**BID CLARIFICATION #2**

**DUE DATE:** April 10, 2019  
**TIME:** 2:00 p.m.  
**PROJECT:** Northeast Residence Halls Security Camera System  
**PROJECT NO:** 300020  
**LOCATION:** University of Connecticut  
Capital Projects & Facilities Procurement  
3 Discovery Drive, Unit 6076  
Storrs, CT 06269  
Attn: Cesar Alonzo

- c. Addendum #1 issued by Christopher Williams Architects on March 14, 2019

This Addendum forms a part of and modifies the original documents issued for bidding, dated February 15, 2019 to the extent noted herein.

SHEET: **0476-1** of

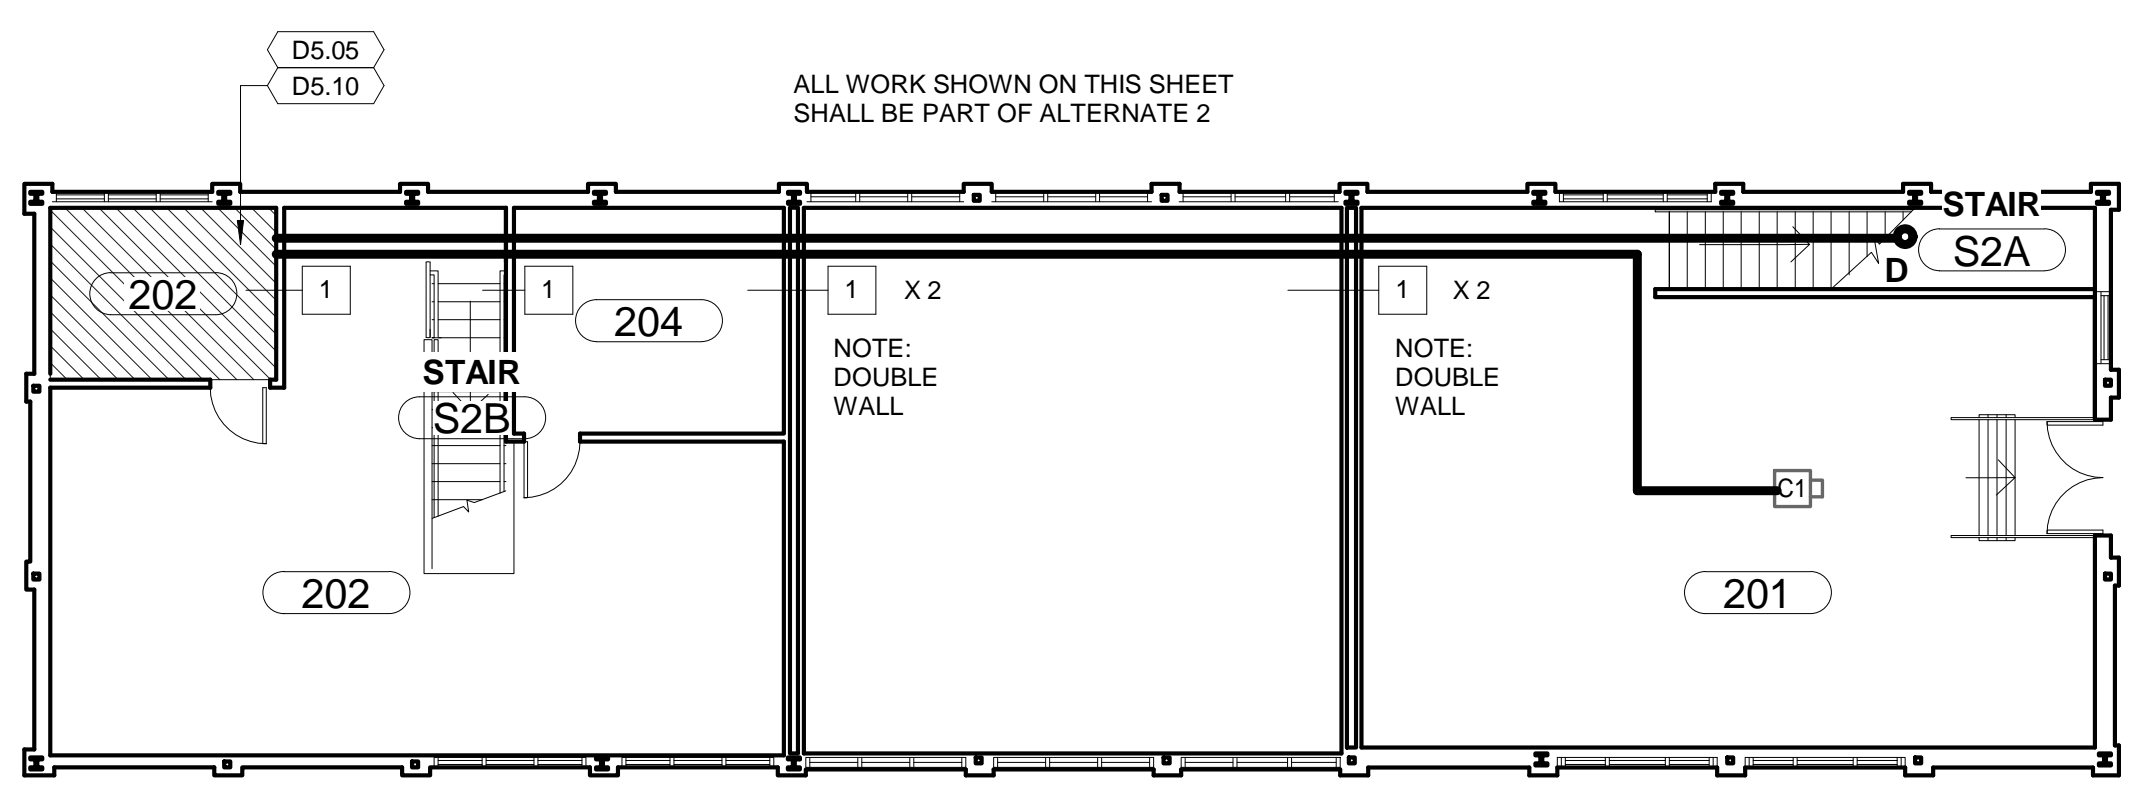
- **Cover Sheet**  
Sheet list revision to include Addendum #1
- **A-0476-1 – Towers – Dining Hall , First Floor Plan**  
**Replaces previous drawing sheet : 0259-0 of the same name.**  
Added notes, camera mounting locations, ceiling heights and types for clarification.
- **A-0476-2 – Towers – Dining Hall , Second Floor Plan**  
**Replaces previous drawing sheet : 0259-1 of the same name.**  
No changes to drawing, sheet number only.
- **REPLACE 0436- 1- Towers – Quad Building G- First Floor Plan**  
Added notes, camera mounting locations, ceiling heights and types for clarification.
